P 515276

ON-SITE SEWAGE DISPOSAL SYSTEM HOWARD COUNTY HEALTH DEPARTMENT BUREAU OF ENVIRONMENTAL HEALTH

SUBDIVISION: The Paddocks LOT NUMBER: 8

ADDRESS: 13705 Bold Venture Drive PROPERTY OWNER: Pulte Home Corp.

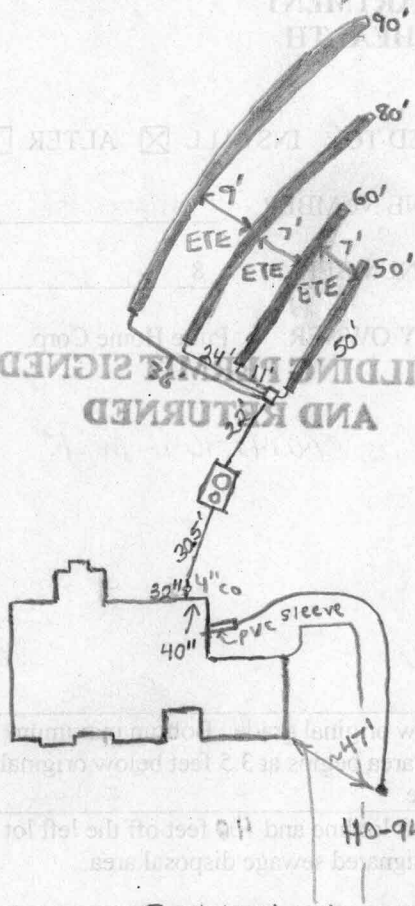
PRE-CONSTRUCTION INSPECTION: 6/15/01 O.K. to install top trench 6" deeper, to try to

keep house connection 18" below grade. Builder to have plumber lower existing

INSPECTION COMMENTS: connection 6". (BB) 6/18/01 50 and 60 foot trenches done.

Need house connection. (BB) 6/19/01 - SYSTEM COMPLETE PENDING HOUSE CONN. (SRV)

7/6/01 House connection done. (BB)
